Inconsistency at expected number
of cycles in CD mode for OVC-HEVs

Proposal for amendments - ANNEX XXI, Sub-annex 6 (void test)

ANNEX XXI, Sub-annex 6 Figure A6/1

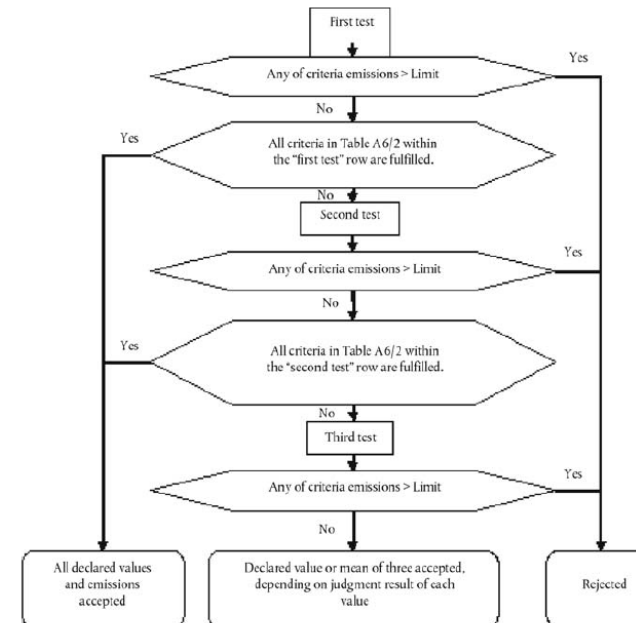
- In the current Regulation it is unclear which cycles will be used for the averaging calculations.
- This is something not likely to happen, however the specific situation is not currently covered by the Regulation.

- 1.2.3.2. Depending on the vehicle type, the manufacturer shall declare as applicable the total cycle value of the CO₂ mass emission, the electric energy consumption, fuel consumption for NOVC-FCHV as well as PER and AER in accordance with Table A6/1.
- Also for OVC-HEVs, the manufacturer shall declare the expected transition cycle number +optionally update Table A6/1, A6/2 ????
- 1.2.3.4. If after the first test all criteria in row 1 of the applicable Table A6/2 are fulfilled, all values declared by the manufacturer shall be accepted as the type approval value. If any one of the criteria in row 1 of the applicable Table A6/2 is not fulfilled, a second test shall be performed with the same vehicle.
- For OVC-HEVs, if the actual transition cycle number does not match with the declared one, the test shall be voided and shall be repeated.
